SKYLINE MINING & RECLAMATION PLAN
PAGES ADDED, REPLACED OR DELETED

Delete:	Add or Replace:
2-100A	4-3
	4-6
Add or Replace:	4-7
	4-8
1-8	4-9
1-14	4-9A
1-15	4-9B
1-16	4-11
2-23	4-12
2-23A, Figure 2.3.2-1	4-13
2-23B	4-14
2-31	4-15
2-32	4-16
2-33	4-18
2-34	4-19
2-35	4-19A
2-42	4-19B
2-43	4-19C
2-44	4-19D
2-48	4-19E
2-49	4-19F
2-64	4-19G
2-64A	4-19H
2-68	4-24
2-68A	4-26
2-86	4-26A
2-86A	4-26B
2-89 Figure 2.9.2-A	4-30
2-100	4-35
2-101	4-36
2-114	4-37
2-115	4-38
2-117	4-39
2-140	4-41A
2-141	4-56
3-3	4-57
3-3A	4-57A
3-21	4-61
3-25	4-62
3-26	4-62A
3-26A	4-65
3-39	4-69
3-40	4-69A
3-40A	4-74A
3-42	4-84
3-59	4-88
3-59A	4-88A
3-64A	4-90
3-64B	4-93
3-64C	4-93A
3-67	4-94

FIGURE 2.3.2-1

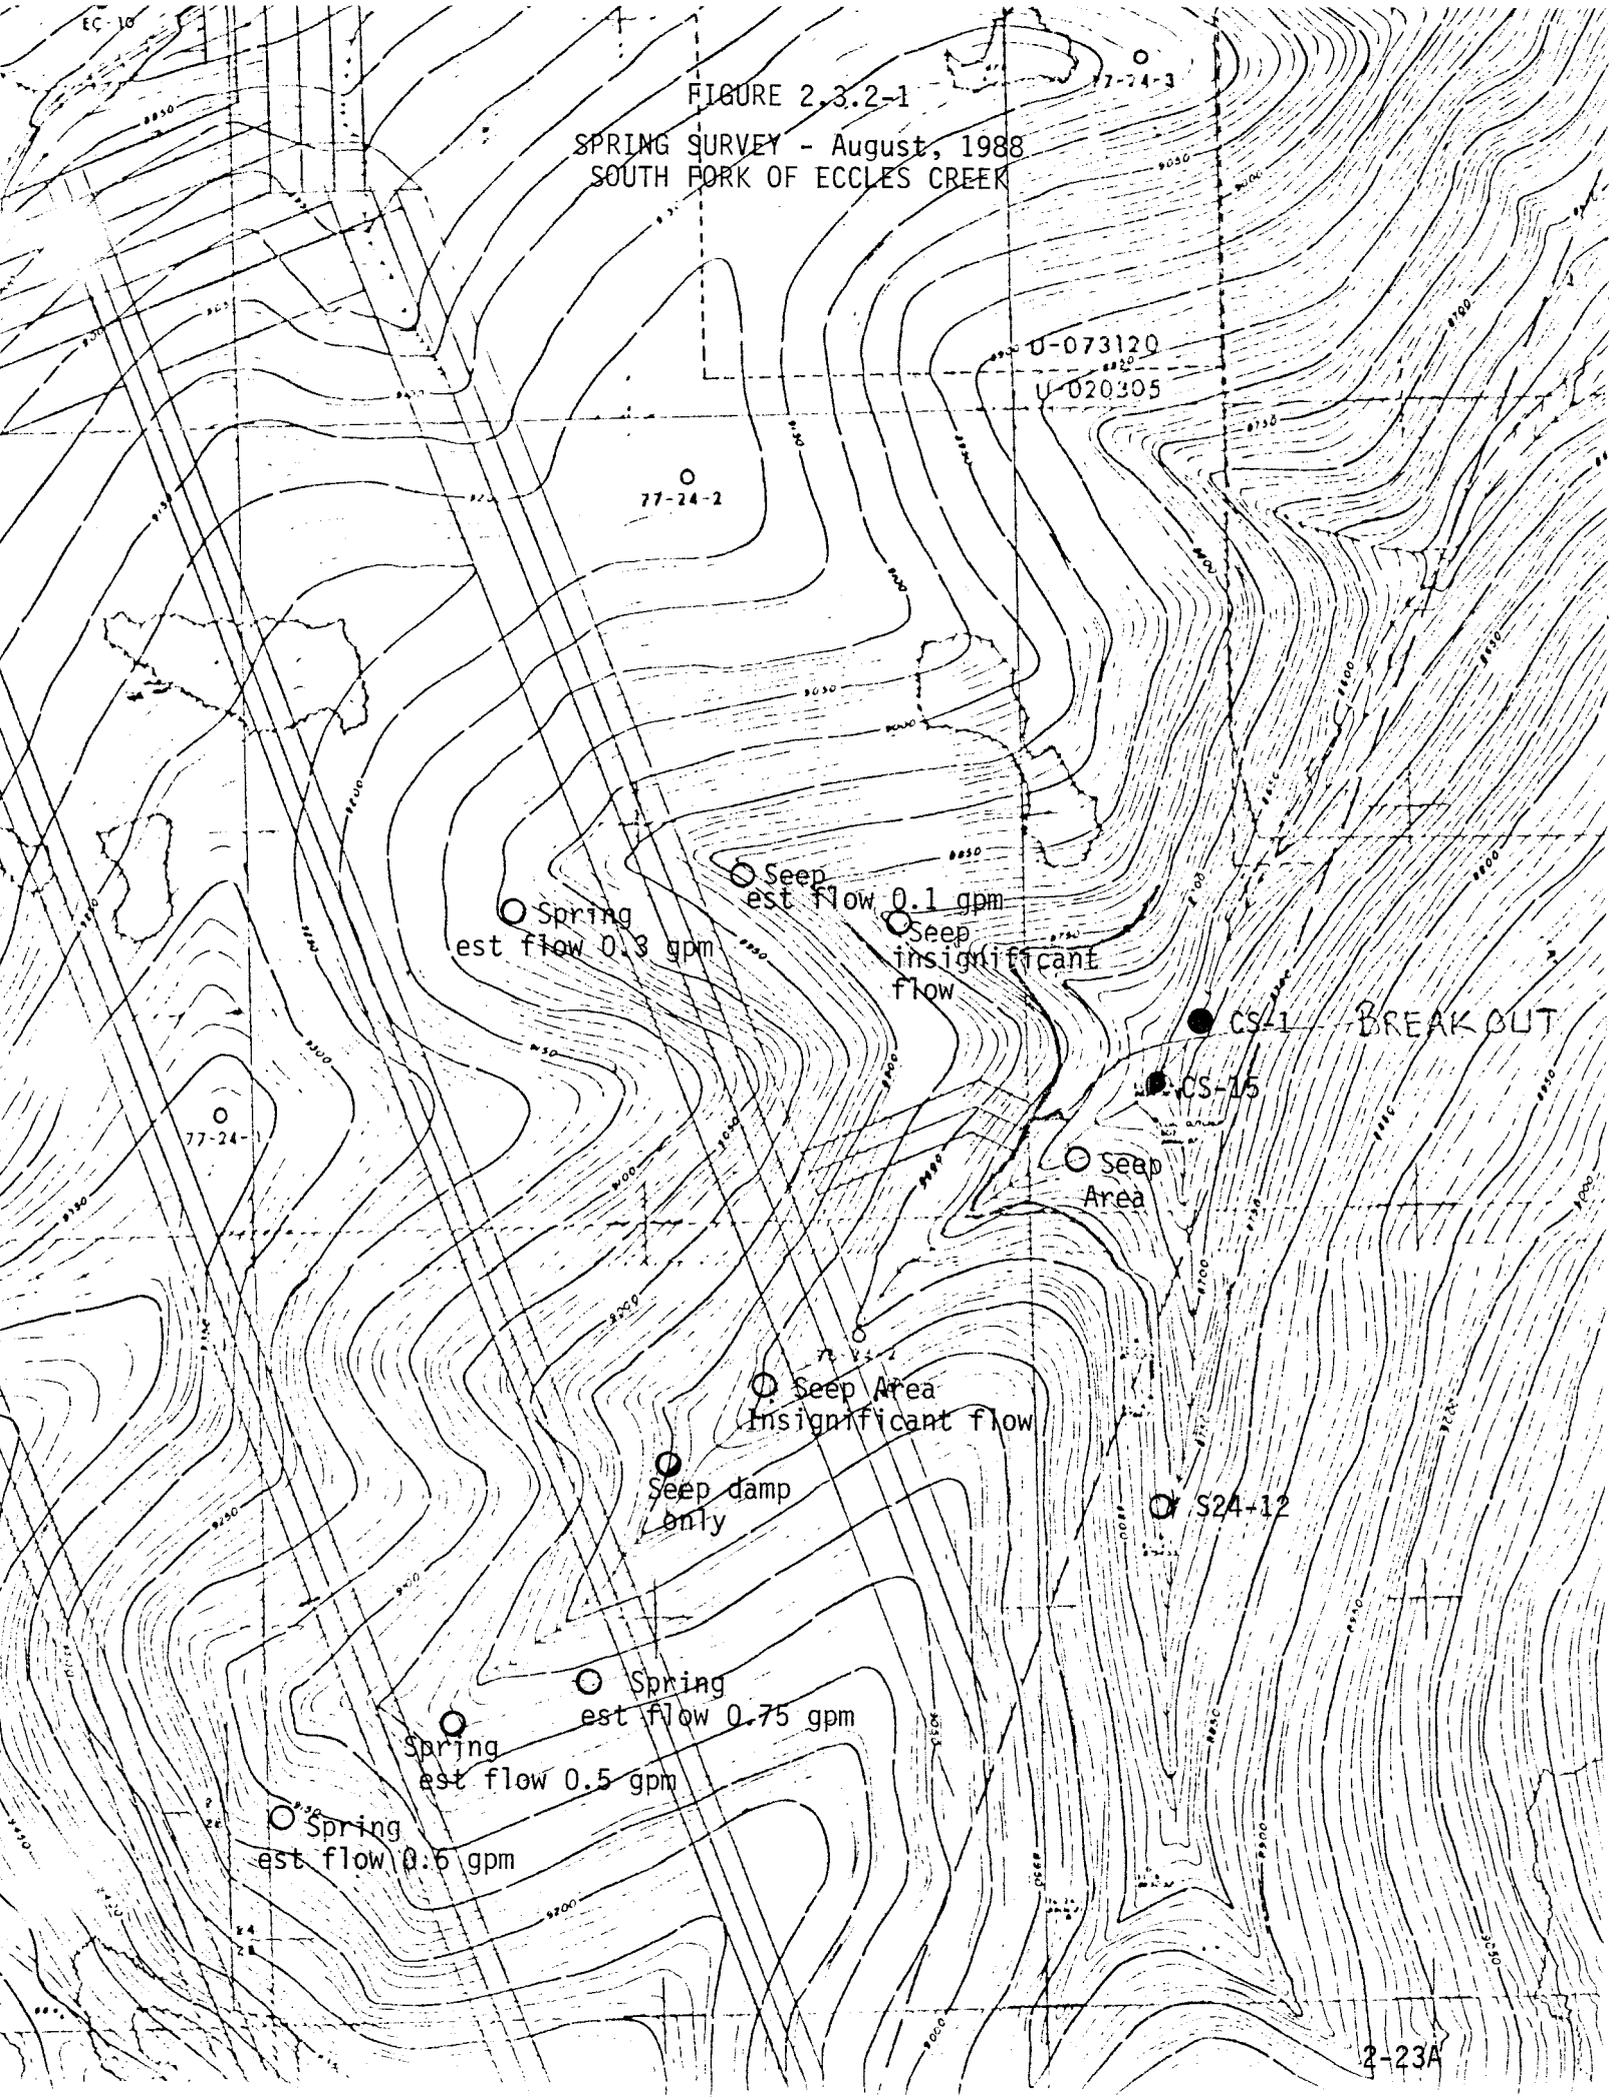
- * As requested by the Division, the operator conducted a survey of springs in the South Fork of Eccles Creek area where mining will take place during this permit term. This survey, conducted during the summer of 1988, varies slightly in locations from that found in the consultant's report. The differences are most likely the result of mapping errors. The results of this survey may be found on Figure 2.3.2-1.

Fig. 2.9.2-A Winter range and migratory route of elk living in the environs of the Skyline lease area

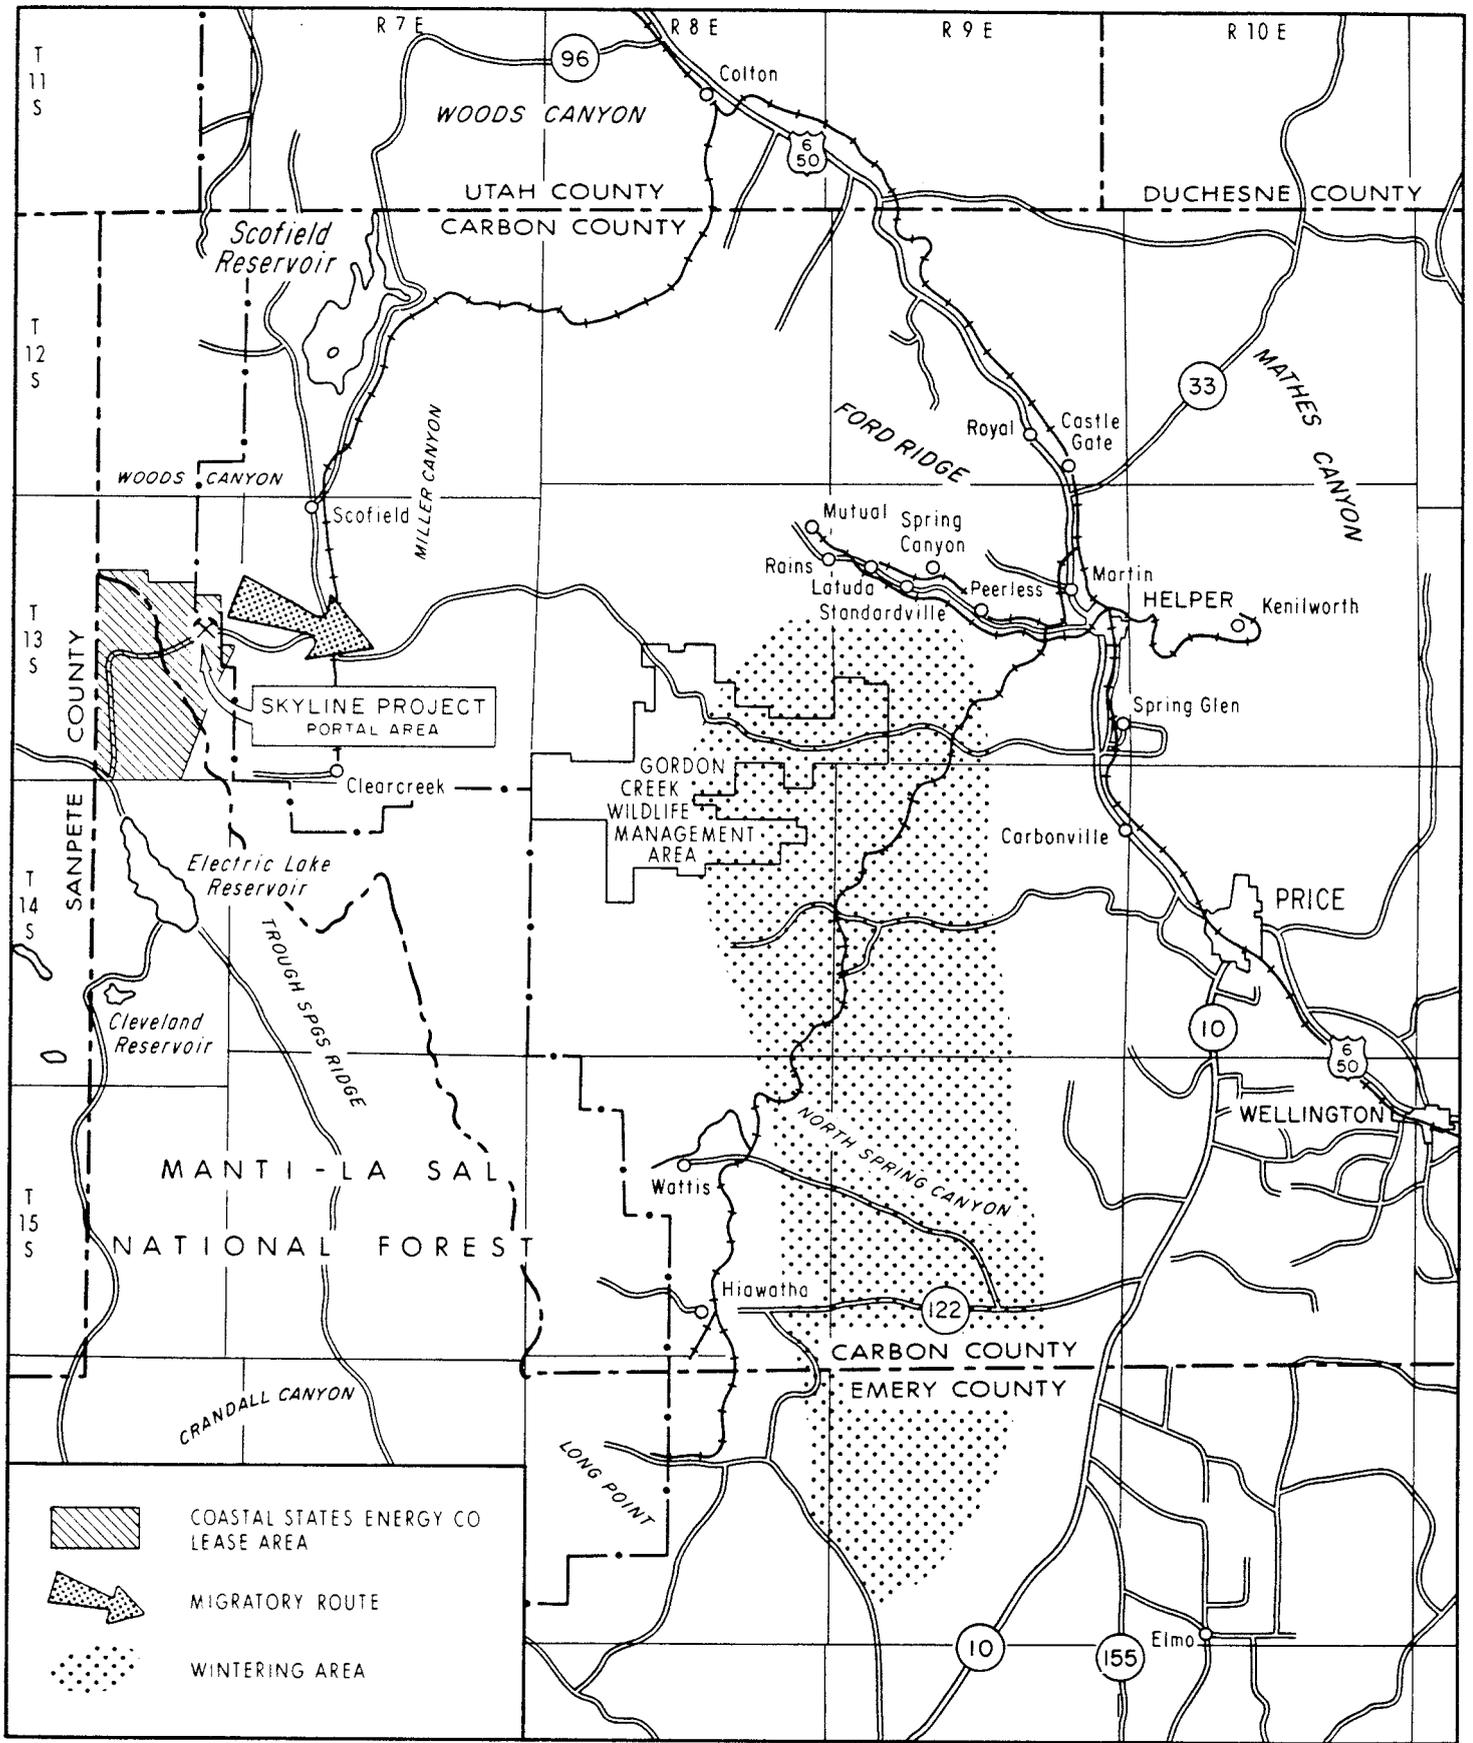
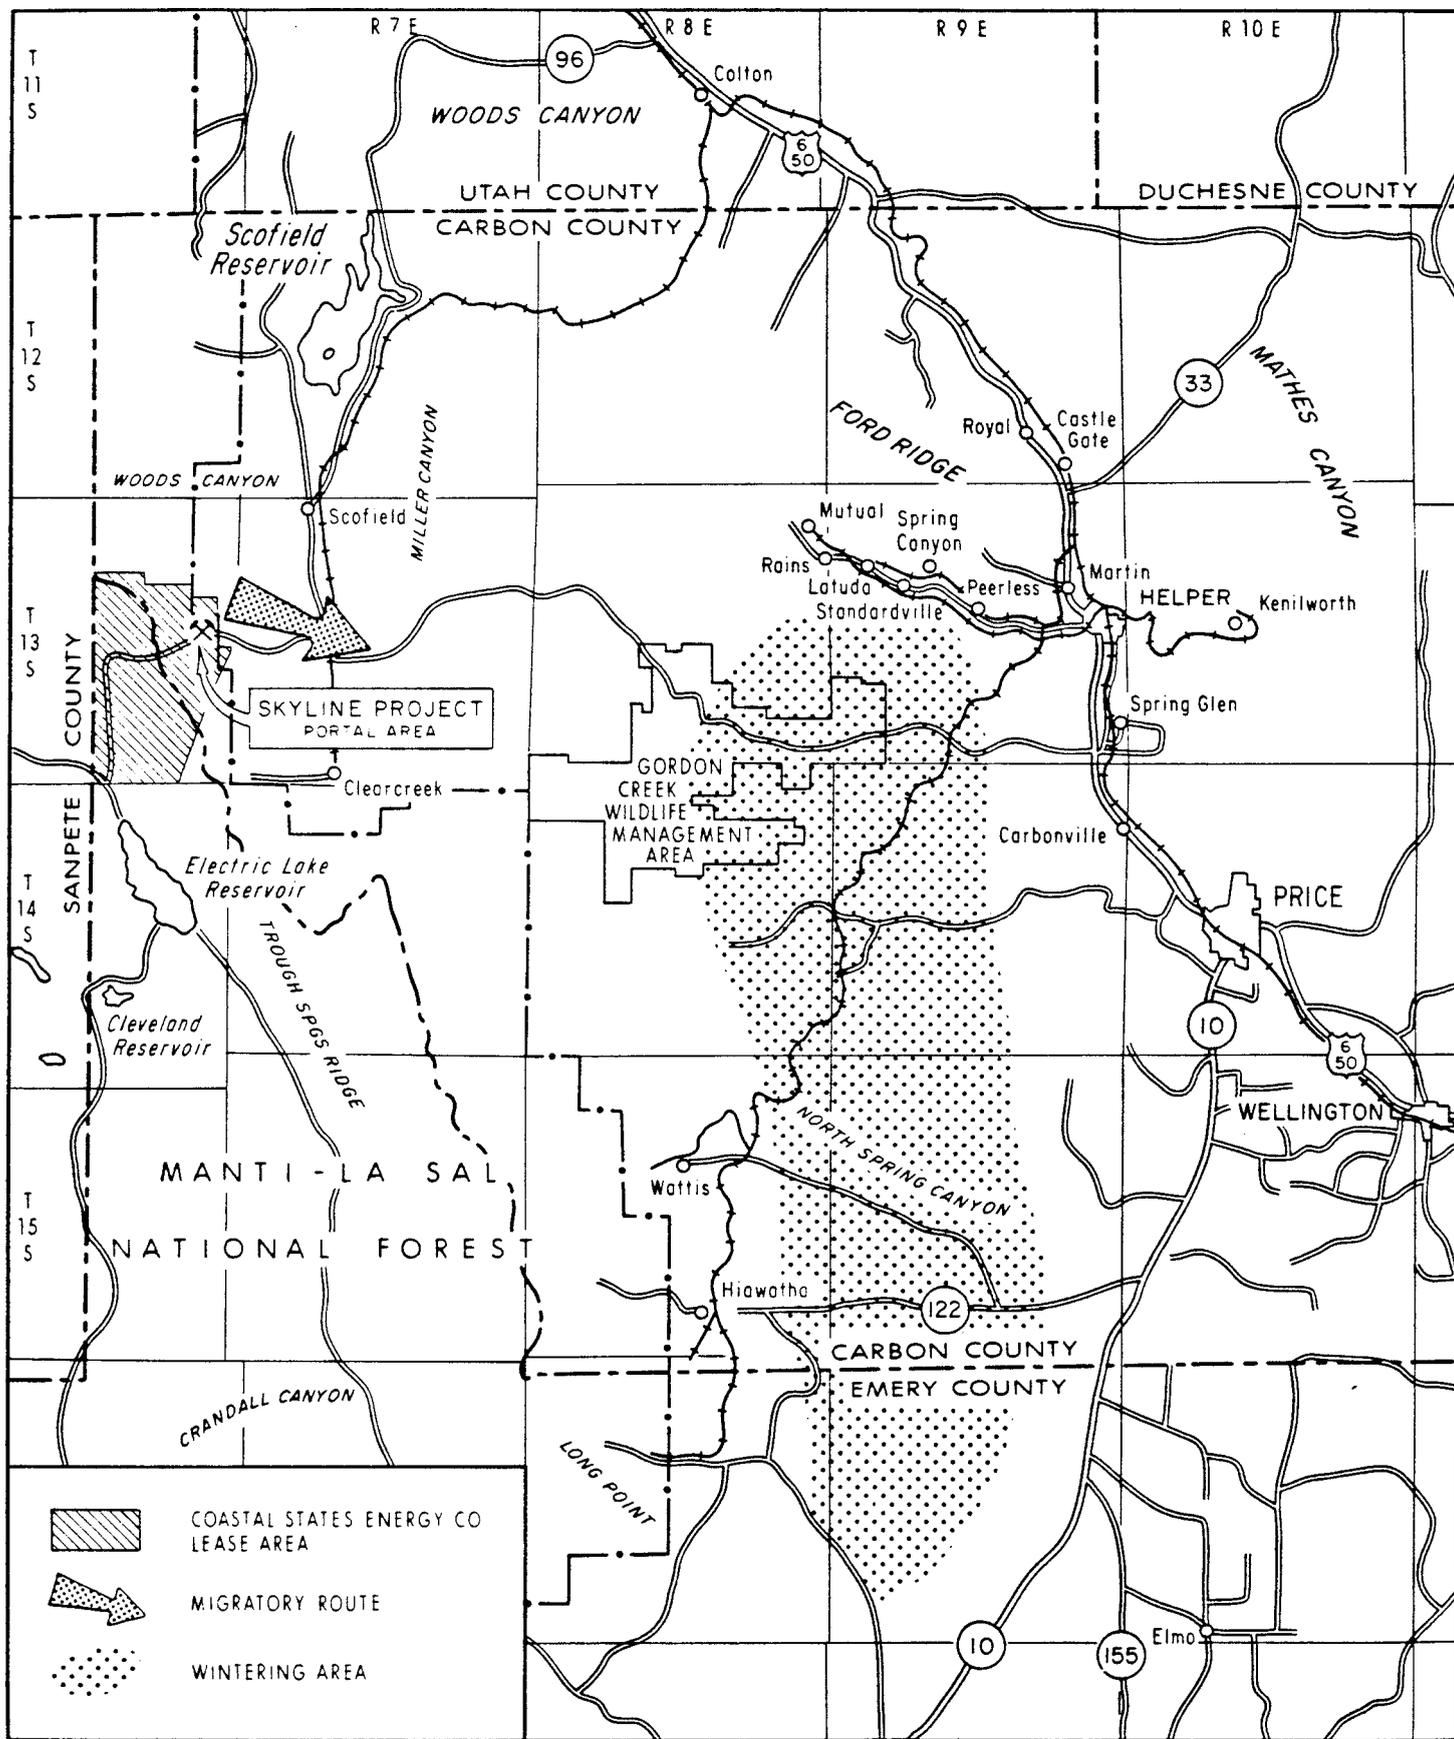
REPLACES	!!	TEXT
Figure 2.9.1-A Page 2-89	!!	Figure 2.9.2-A Page 2-89 Date 10/15/88!
* Denotes change or addition
